Code Test & Results

Code Test & Results

THE CODE TEST.

Site #1 (SPA3)

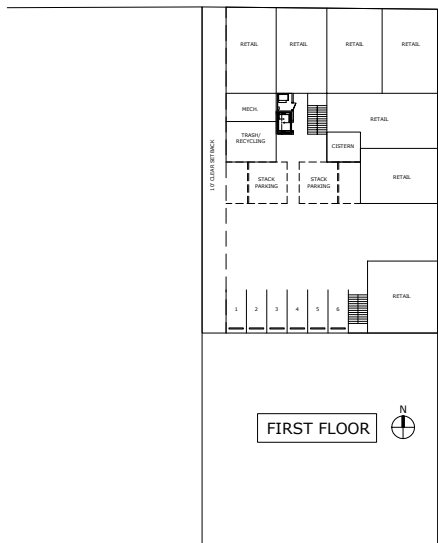
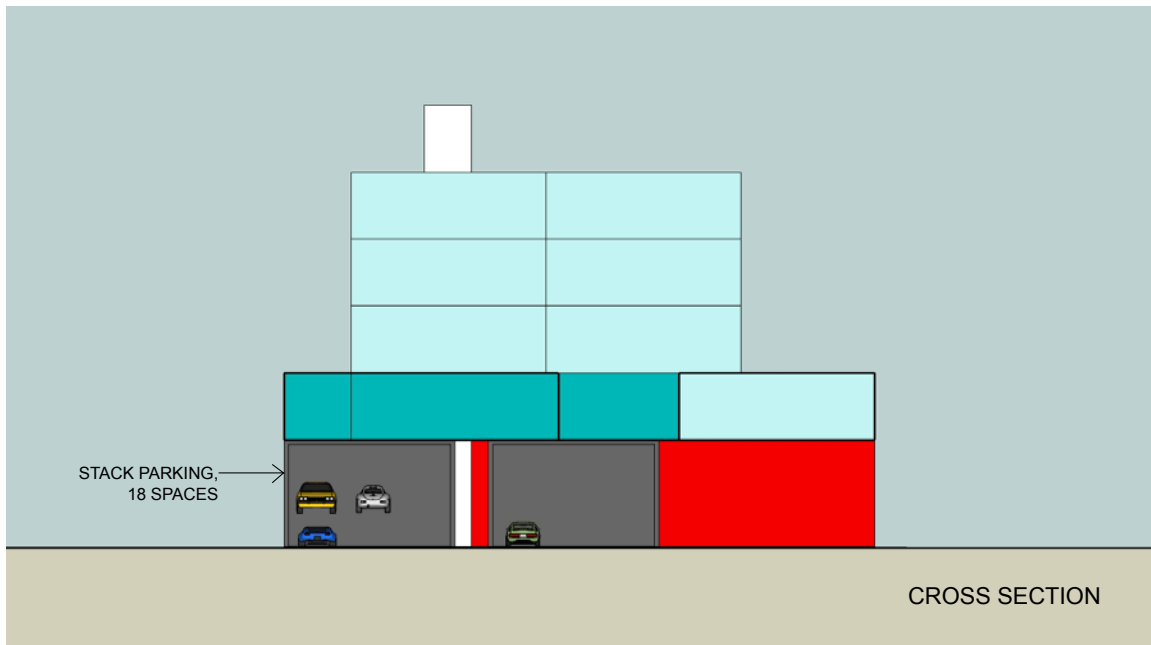
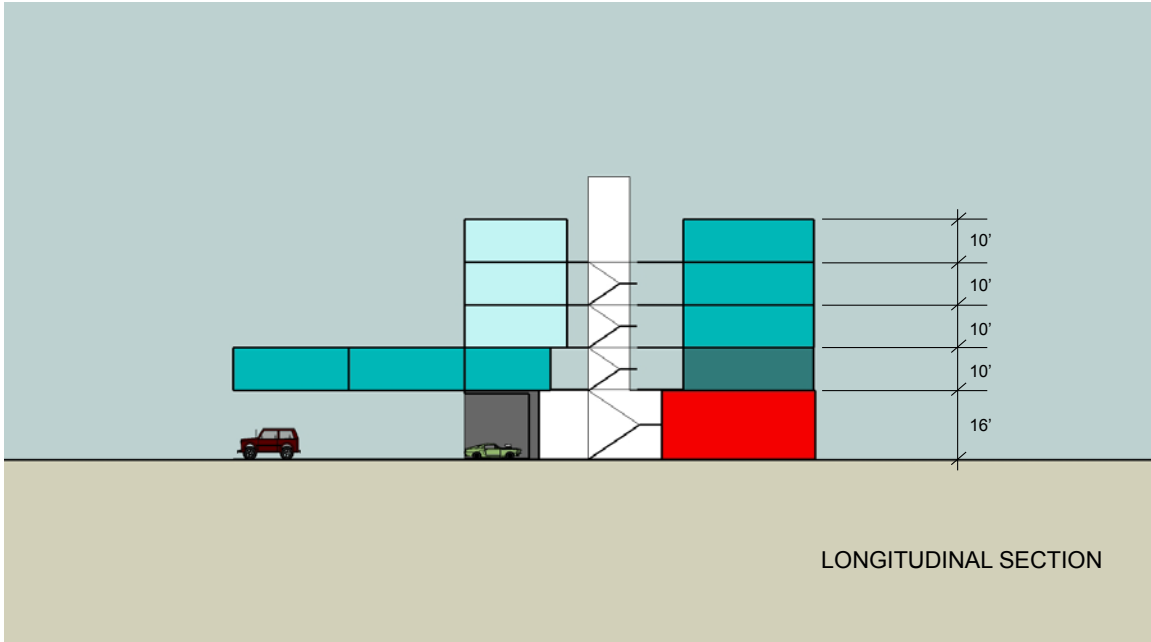
Site #1 code test for the redesign of a southwest corner lot commercial/retail plaza meets all of the code requirements, and exceeds the density requirement (actual 78 units/acre) by 30%. There is no access to the residential units on San Pablo Avenue, so this condition should be specified more clearly. The pedestrian access for the residential units is through the parking area, which is the model the “commuter condos” follow, and is not the intention of the Ecotone code. However, this design could be easily modified to address this change. The interpretation of existing land uses incorporated into the new building was non-specific. The sun slot setback begins at the southern property line, as specified in the code and extends for 54 feet. The intention of the sun slot standard, although not clearly stated, is to have a sun slot for every 50 feet of frontage. The different interpretation of the standard requires clarification: the sun slot standard can be interpreted as a single setback space from the southern property line, or as a series of setbacks based on the 50-foot increment where there would be a setback from the southern edge of the designated 50 feet, starting at the southern parcel line. The choice allows for variation, while upholding the basic concepts.

- difficult to re-use existing building w/ requirements of code, this particular site and parking.
- i blew it on the vertical delineation, but what is that anyway? in general, a definition list of common terms would be helpful (e.g. vertical delineation, parcel vs block, etc).

Site #2 (SPA3)

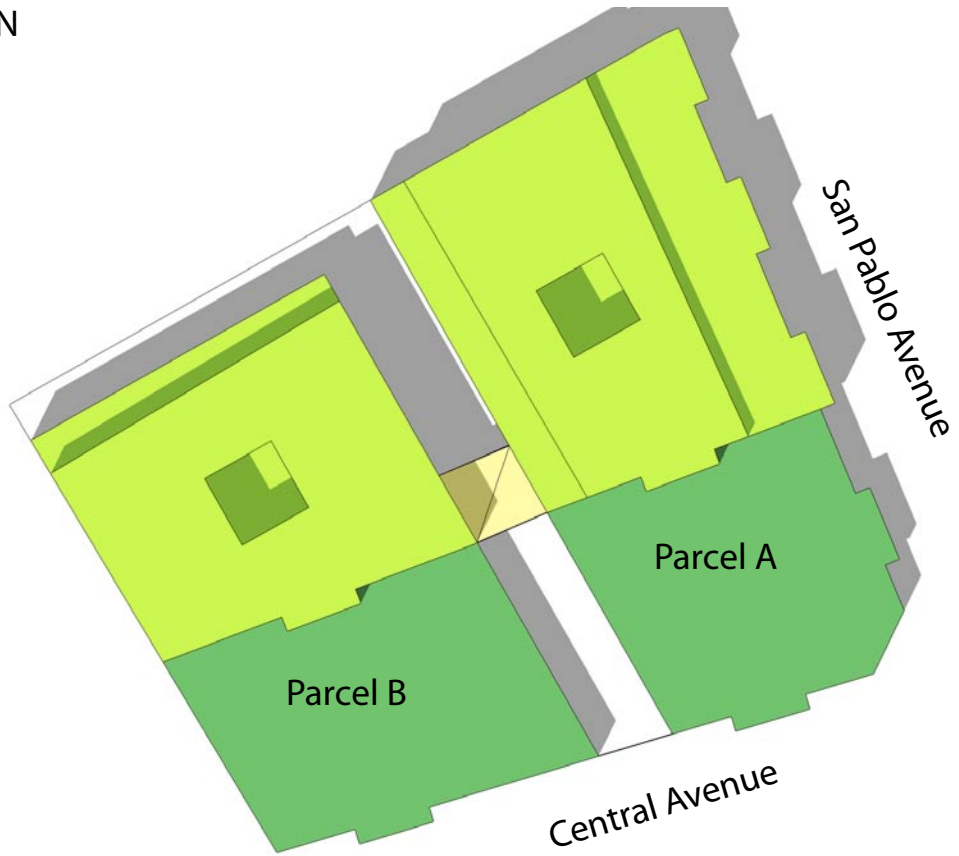
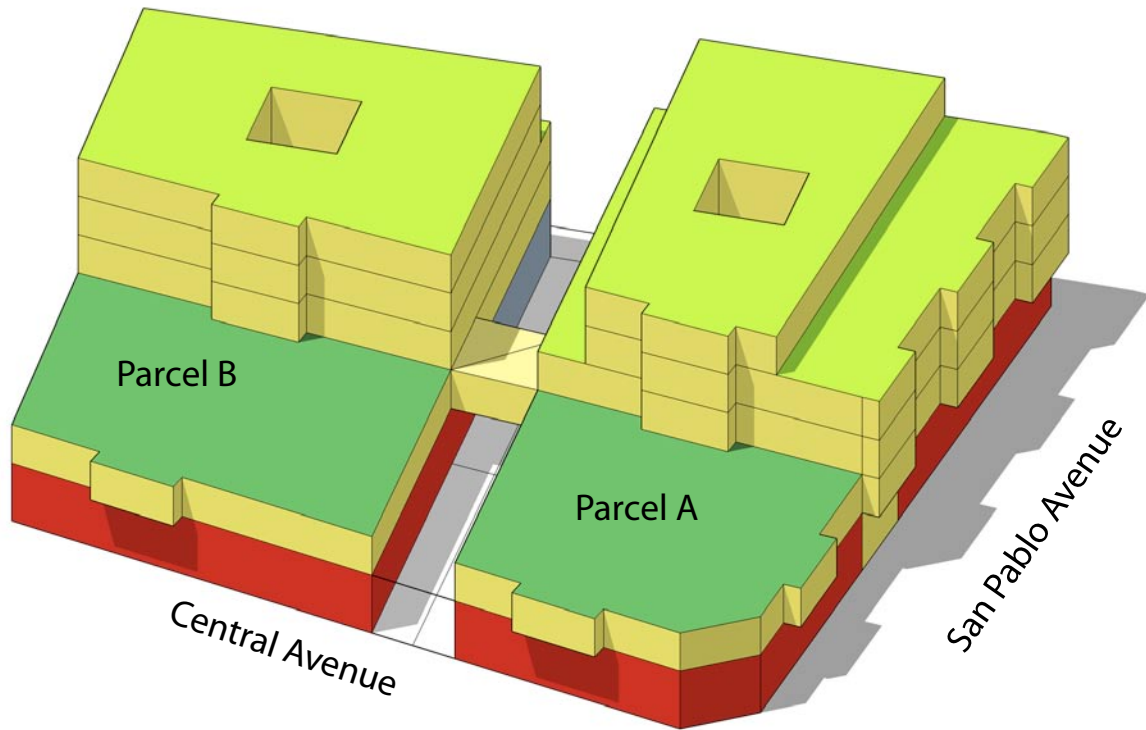
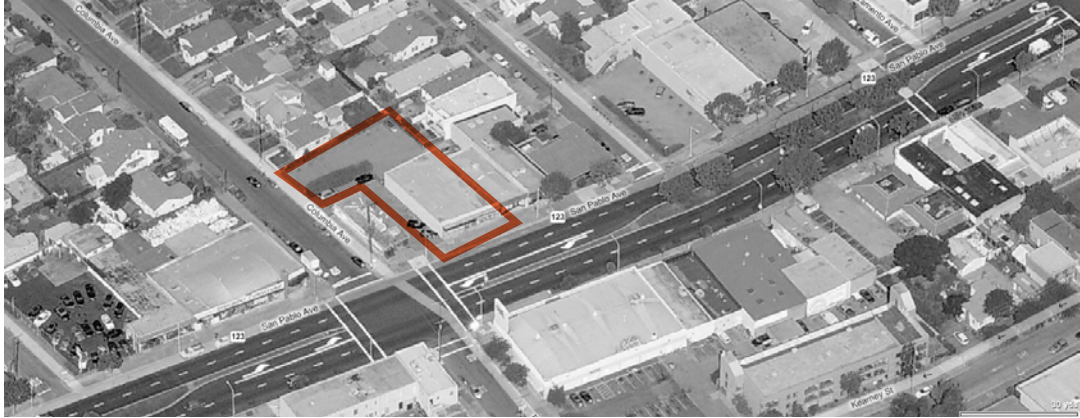
Site #2 code test for the redesign of a northwest corner lot Burger King restaurant meets all of the code requirements except the two-exposure ventilation standard and the commercial parking number requirement. Since the site is larger than 20,000sf, it is subdivided into two parcels of approximately equal area, with each parcel exceeding the density requirement by at least 30%. The parcel subdivision is parallel to San Pablo Avenue creating a “front” parcel and a “back” parcel. This condition might work for this site given its corner location at the intersection of two major streets, however, the subdivision requirement was intended to create parcels perpendicular to San Pablo Avenue, with all parcels having frontage on the avenue. As pointed out by the designers, the sun slot standard is “really problematic for a corner parcel on the north side of the street. We (the designers) ended up losing all of the corner presence of our building.” Corner presence is a basic tool of urban design, where building heights define the public realm of an intersection, creating a type of gateway. Height on corners has the same effect as increasing the line weight at the corners of a line drawing; it adds emphasis. Clearly, an adjustment to the code needs to account for the sun slot standard at intersections. There are two types of solutions for this refinement: remove the sun slot standard at intersections or offset the setback line by a certain distance. In theory, the parcel size limitation of 20,000sf would create a frontage 200 feet long for the average parcel depth of 100 feet. Based on the two-exposure standard for residential units, the open space standard, and the 50’ vertical delineation frontage standard, a 50-foot setback for the initial sun slot for north-side parcels at intersections is a refinement consistent with the concepts in this code.

Returning to a site-specific design issue, the single entrance for the residential units doesn't comply with the two-exposure ventilation requirement in this specific spatial configuration because corridors would be necessary to access the vertical circulation. A second entrance would remedy this issue. Finally, the last two details of note: Interpretation of existing land use incorporated into the new building was non-specific. The designers didn't include parking for the residential uses because they felt it would be counter-productive to the development incentives.

The design of Site #2 brought up some unaddressed issues: the skywalk and parking access for subdivided parcels. The skywalk connecting buildings assumes a single owner and probably a similar architecture. Is this consistent with intentions of the 50' parcel rhythm for the cultural landscape and pedestrian scale concepts? Yes. A size limit could be applied to skywalks and other building connections to prevent the perception of the two buildings reading as one structure. Parking access for this site is on a secondary street, which is facilitated by parallel parcel orientation, which broaches the question: can subdivided parcels share parking access? Yes, as long as the parcel orientation and frontage requirements are compliant with the code. The author determined the calculations below by measuring the areas in the 3-d computer model provided by the designers.

PARCEL A: COMMERCIAL 10,500sf; RESIDENTIAL: 12,000sf, 8000sf, 7000sf, 4500sf
(less 500sf each level for circulation area) = 29,500sf; PARKING: 1100sf (need 10 spaces for
commercial, only accounted for 5.5 at 200sf per space)

PARCEL B: COMMERCIAL 10,500 RESIDENTIAL: 11,200, 6000, 5200, 5200 (less 500sf
each level for circulation area) = 25,600; PARKING: 1100SF (need 10 spaces for commercial,
only accounted for 5.5 at 200sf per space)

Site #3 (SPA2)

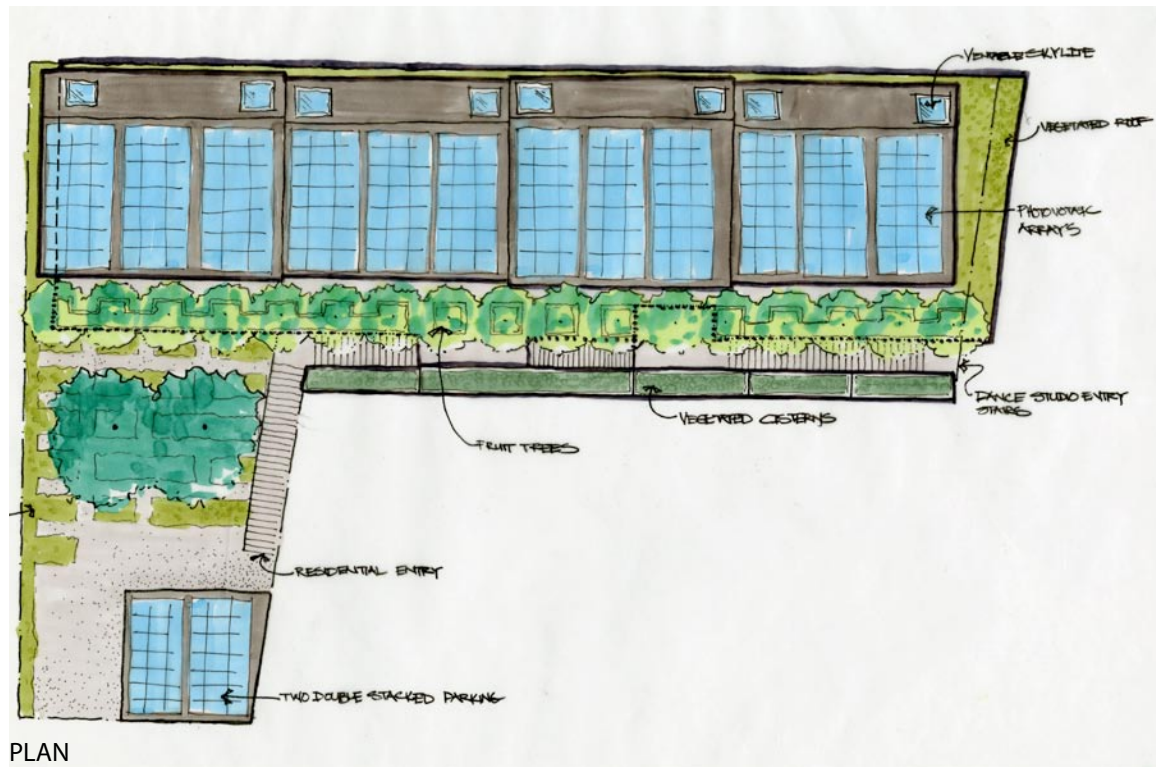
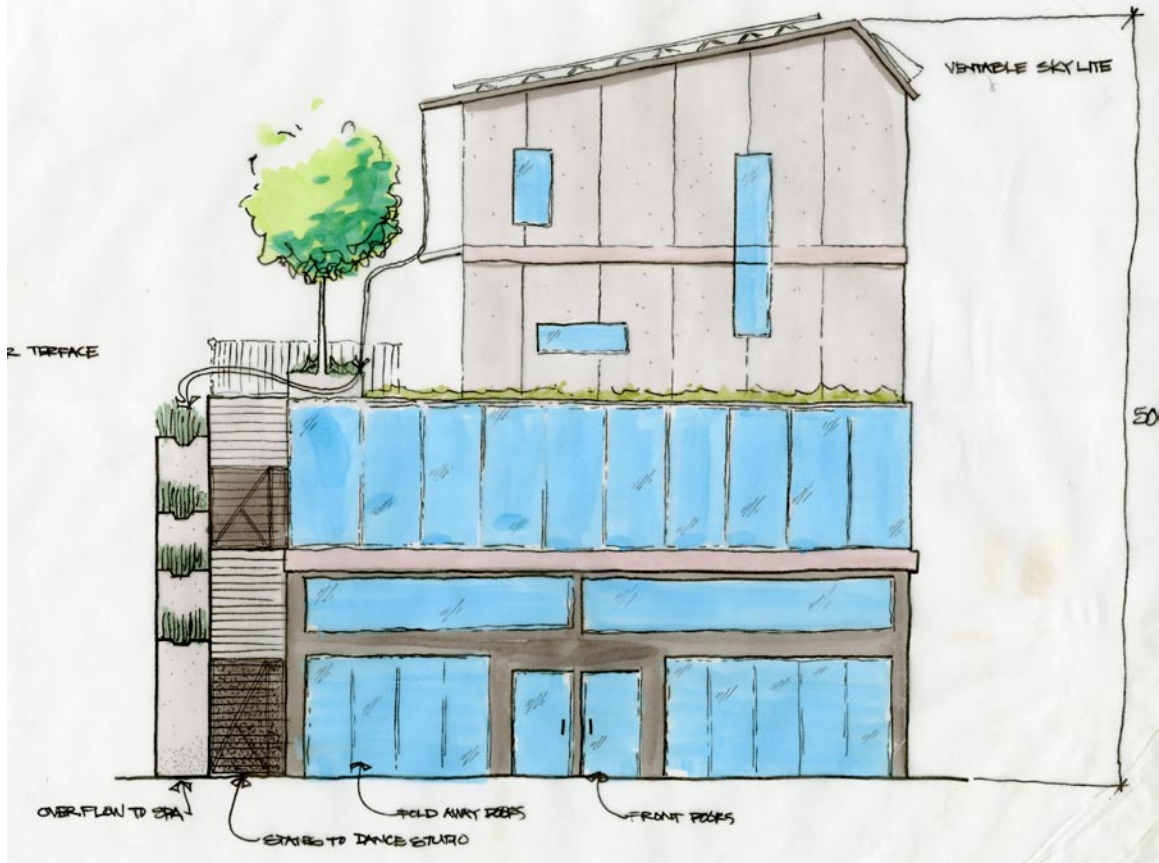
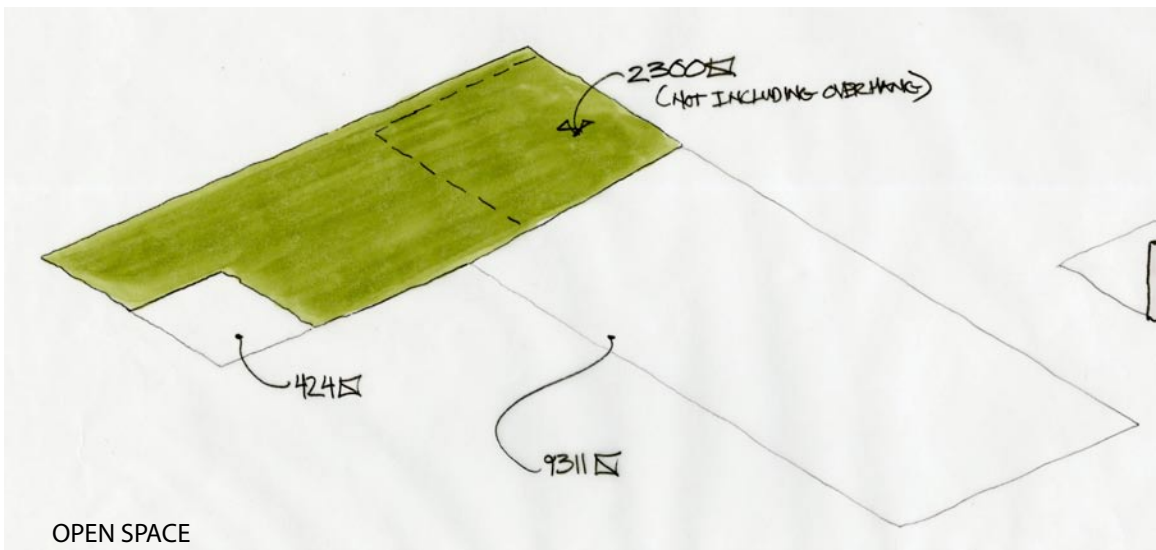
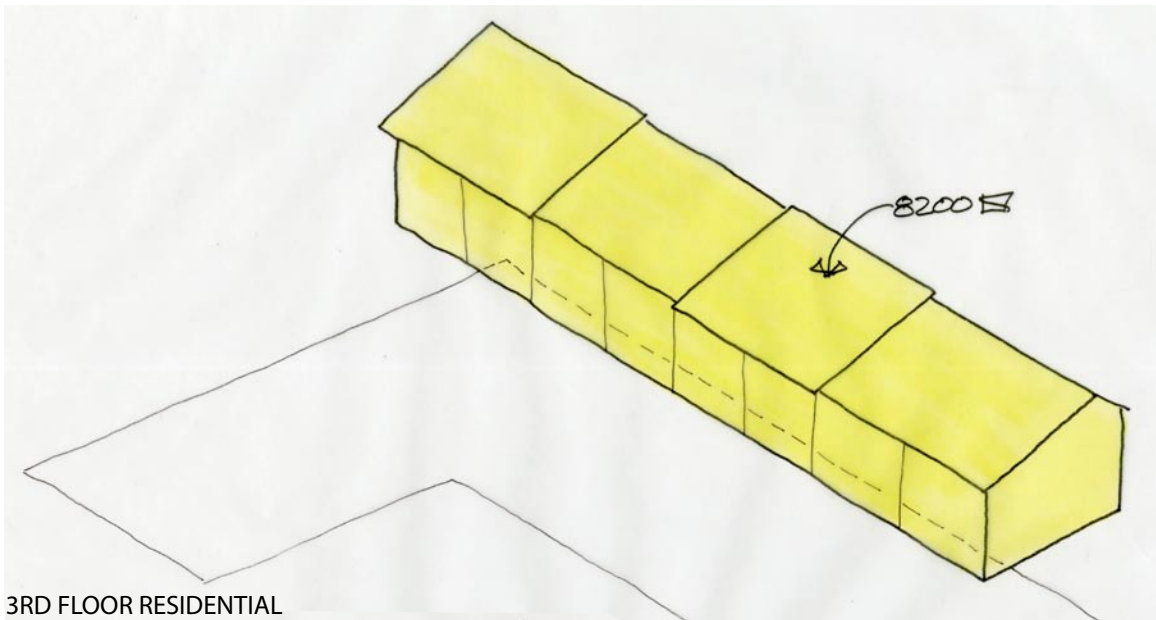
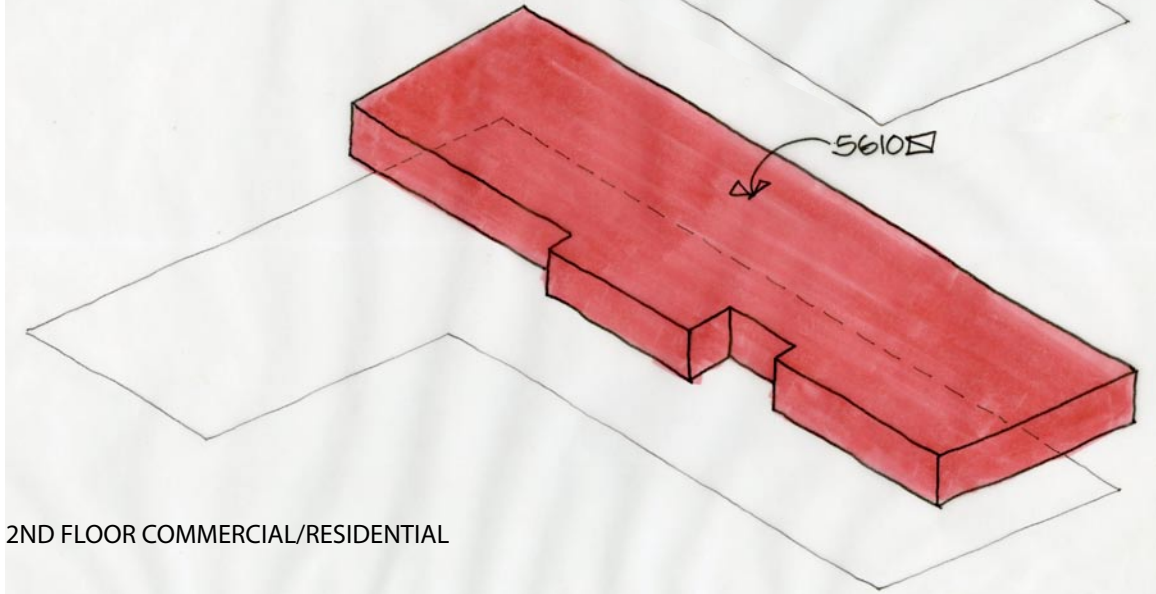
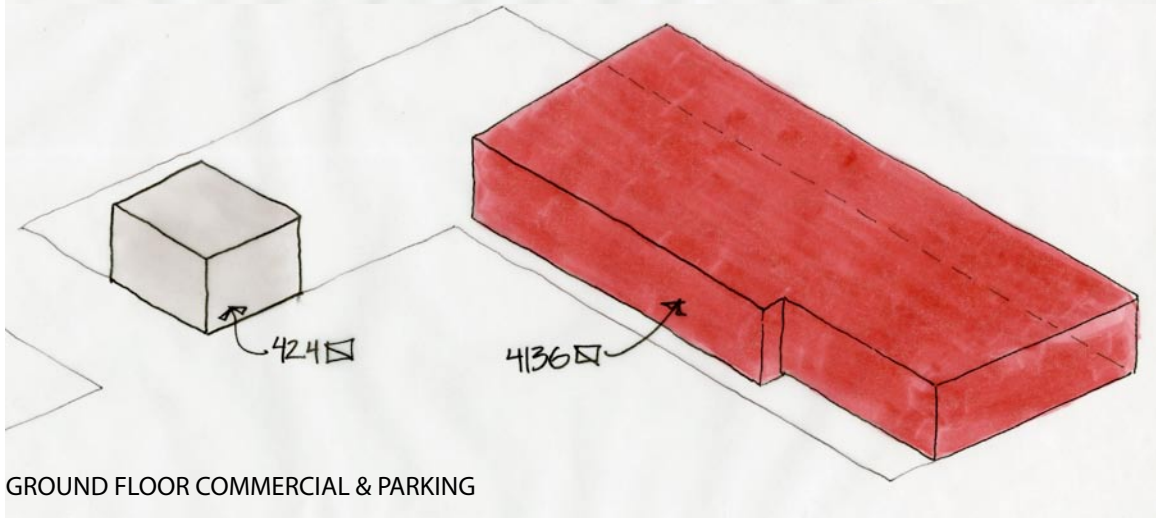
Site #3 code test for the redesign of a mid-block commercial/retail parcel meets all of the code requirements except for the density requirement (actual 37 units/acre). The interpretation of existing land uses incorporated into the new building is specific and the existing building is reused. The unit density could be improved by adding two residential units to the second floor in lieu of the additional commercial space.

Total parcel sf = 9311sf with 8 units = 37 units/acre (-8%)
